# STONEY STANTON PARISH COUNCIL

6<sup>th</sup> November 2023

## **Consultee objection to Highfields Farm Development application 23/0740/FUL**

Fig 1 Shows the locations at the end of Clint Hill Drive and manholes adversely affected each time there is significant rainfall.

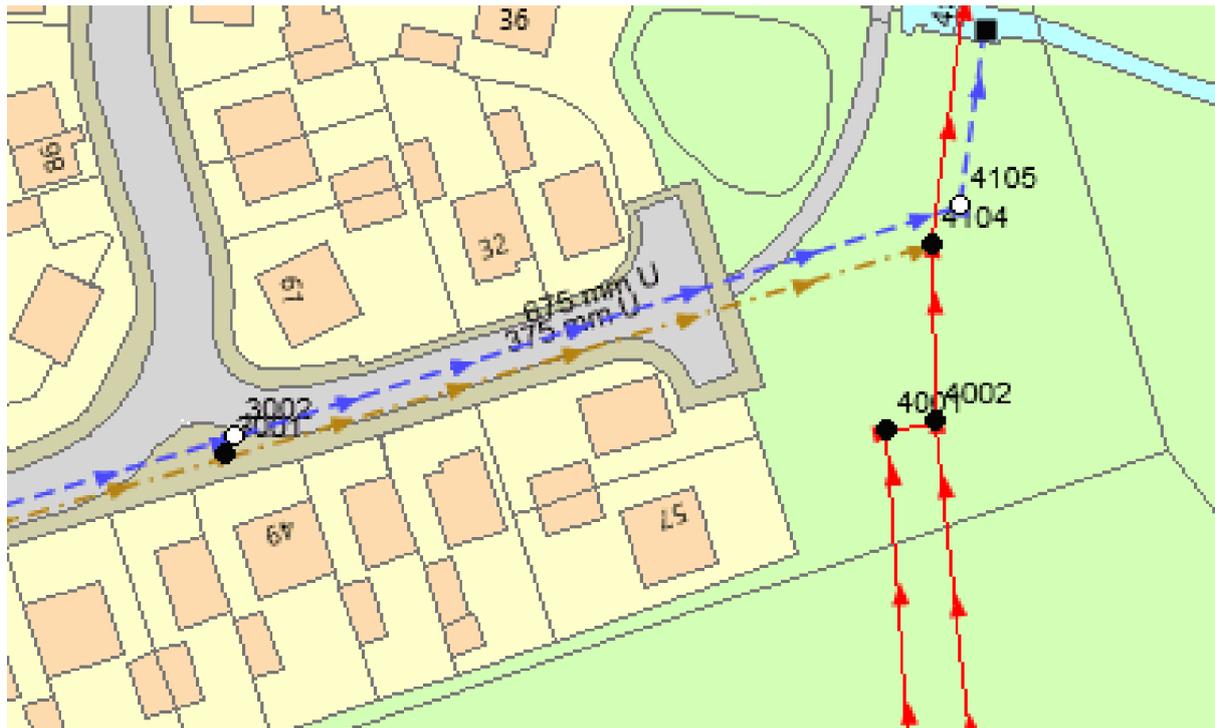
There have and continue to be significant issues with the water systems in and around the village that are not sufficient for the volumes of water and waste they are expected to currently carry. This application and its report do not consider the complex water system or indeed reference the current condition and base all work of theoretical model's not actual conditions. For the past 6 years SSPC has monitored the situation in the village and in significant periods of rainfall the sewerage system that runs along Clint Hill Drive which this development will join in to at Mays Farms Drive. The system spews raw sewerage from the foul manholes into the road and road water drainage system and comes up through neighbouring properties showers and toilets. Severn Trent in response to the complaints made by SSPC state "what you are experiencing is hydraulic overload..... we have no control over excessive rainfall that can overwhelm the sewerage system". Given the acknowledgement that the system is overwhelmed even during seasonal heavy rainfall, adding anything further to this system as per the proposal would be detrimental and make a bad situation even worse. See appendices for the e-mail copy. The photographs in the appendix of this report show the system on 20<sup>th</sup> October 2023 at Severn Trent identification points 3001, 3002, 4104 and 4105 after a heavy but not unseasonal rainfall of 43.8mm in 38 hours fell. This is a common occurrence and has been reported regularly by residents and SSPC for multiple years. Furthermore, the foul water system is regularly overflowing into the storm water system at points 8001 to 8004 on the Severn Trent identification maps polluting the Manor Brook and river Soar subsidiaries. Furthermore, significant flooding occurred 1<sup>st</sup> October 2019 affecting 34 properties which was a 1 in 13-year storm (source LLC LLFA) resulted in overwhelming of the sewerage and freshwater systems around the village and foul water being detected in the majority of the effected properties. During this period the manholes on Clint Hill Drive and elsewhere were displaced due to the volume and

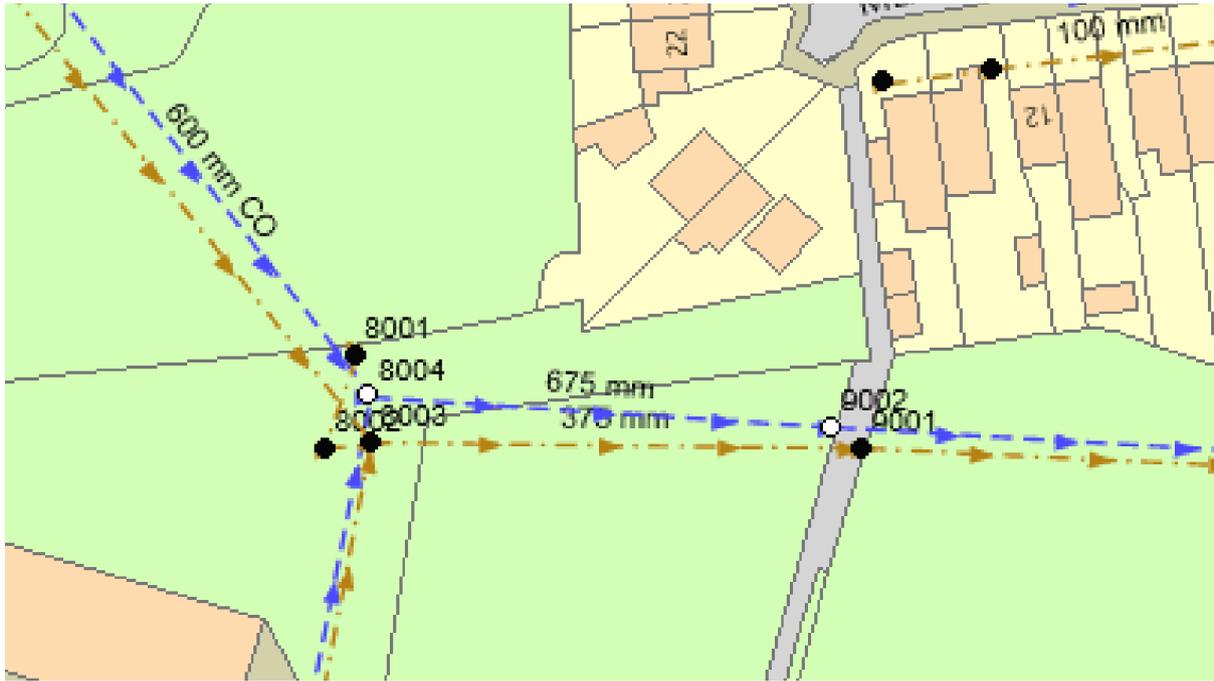
Fig 2 Shows the manhole locations affected to the rear of Meadow Close affected each time there is significant rainfall. Within the structure of 8001-8004 is an overflow from the foul to the surface water system that subsequently over flows both into the Manor Brook and River Soar where the flow ultimately finishes.

Fig 7 What appears to be ground vents in multiple locations across the site that do not appear to be mentioned in the proposal supporting documentation.

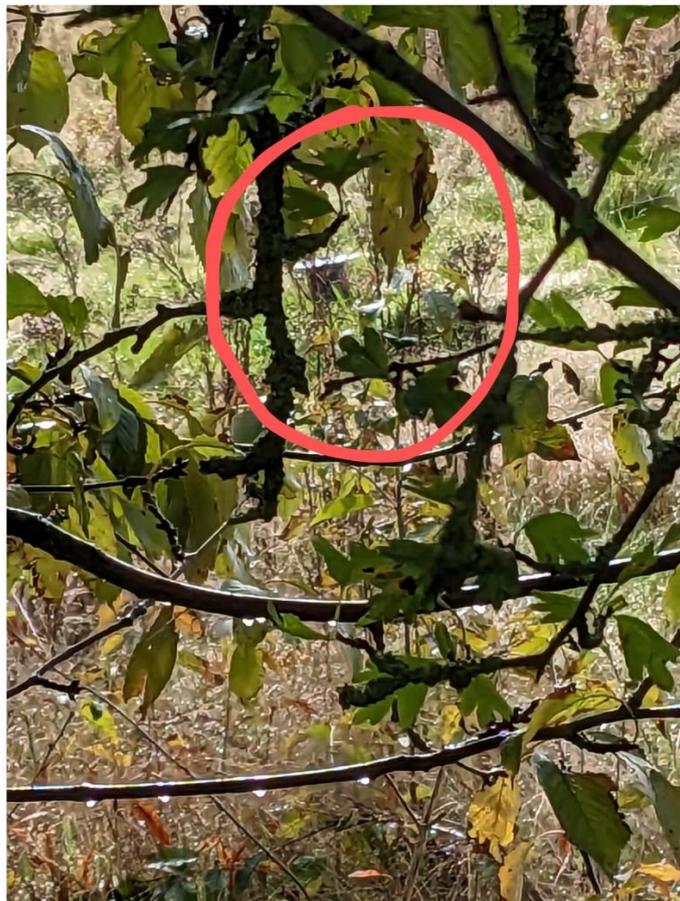
Whilst it is noted that the site is unused agricultural land, and has in the past been used by football teams, there appears to be ground vents located at a number of locations on the site (see appendix 1 for pictures). In the application there is no reference to these vents, or what they are for including any documentation to confirm they are no longer needed or suitable mitigations in the building of the site and monitoring requirements going forwards.
